Technical Service Bulletin

Cobra Motorcycle Mfg.

TSB0309 Cobra Frictional Drive (CFD) Version 2 (V2)

September 18, 2008

Figure 1

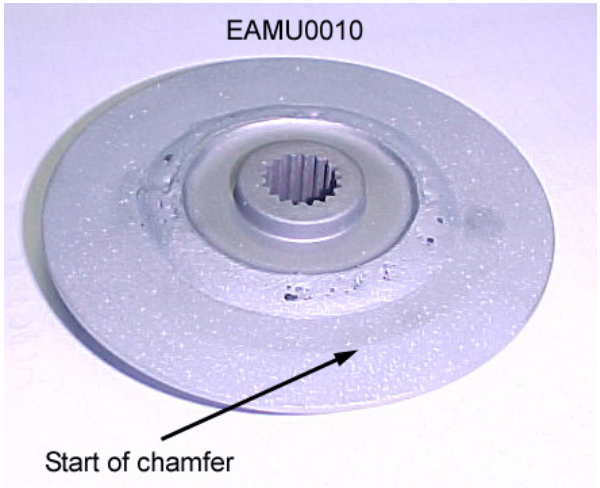
For 2009 the CFD “slipper” hub/pressure plate and centering washer have been improved. The old CFD hub/pressure plate (EAMU0008) is being discontinued and is being replaced with part number EAMU0010. The EAMU0010 must be used in conjunction with a new centering washer (ECMU0169) which replaces the previous ECMU0160.

The new style CFD hub/pressure plate can be identified by the presence of a slight chamfer on the back surface (figure 1). The new style centering washer can be identified by the presence of a large radius on the outer edge (figure 2).

This new CFD hub/pressure plate (EAMU0010) is the recommended service replacement part for engines with EAMU0008, or even the older two components setup (hub and pressure plate are separate). When making this replacement a new style centering washer (ECMU0169) must be used along with it.
